NTD-NRC-94-4254  
DCP/NRC0178  
Docket No.: STN-52-003

SUBJECT: WESTINGHOUSE RESPONSES TO NRC REQUESTS FOR ADDITIONAL  
INFORMATION ON THE AP600

NTD-NRC-94-4254  
ATTACHMENT A  
AP600 RAI RESPONSES  
SUBMITTED AUGUST 3, 1994

A non-proprietary drawing of the T/G, MSR, Exciter, Controls, and auxiliary subsystems is added to the SSAR as Figure 10.2-2.

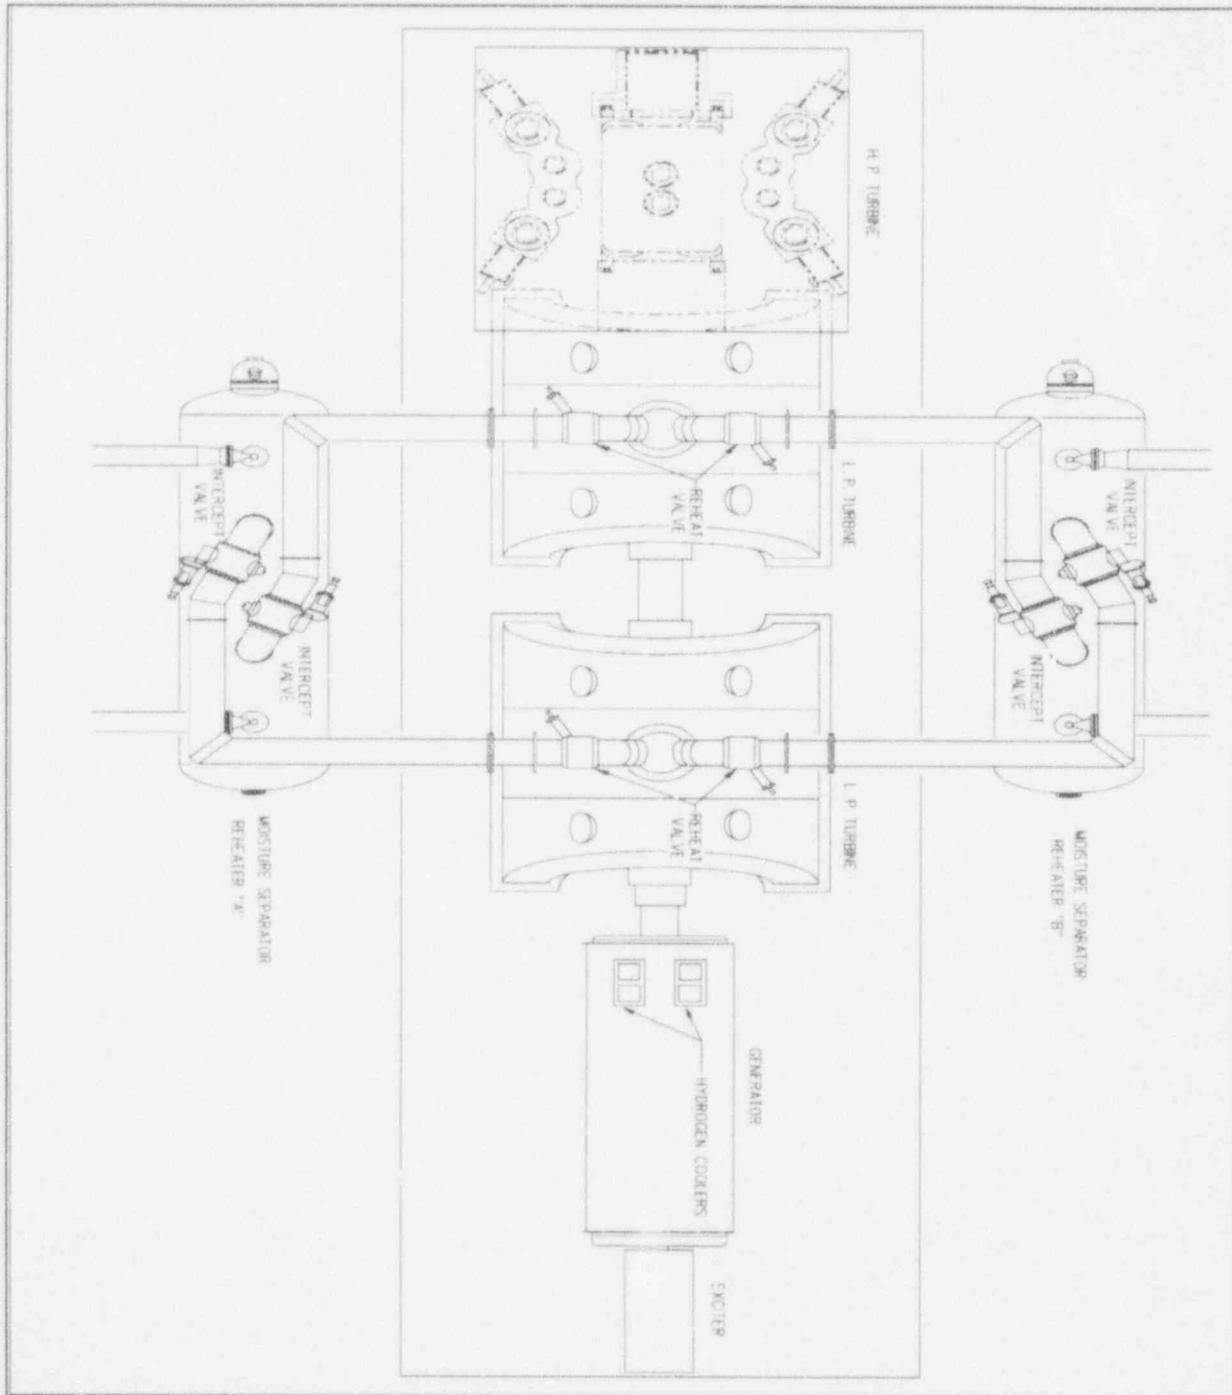
Section 10.2.2 of the SSAR states that the turbine-generator consists of turbines, a generator, external moisture separator reheaters, an exciter, controls, and auxiliary subsystems as shown in Figure 10.2-1. The described components should be in a non-proprietary figure. The function of the exciter is not discussed anywhere in the SSAR. Describe the functions of the exciter in the SSAR.

The components will be indicated on Figure 10.2-2 (Turbine Building Elevation 165 General Arrangement) in the non-proprietary section of the SSAR.
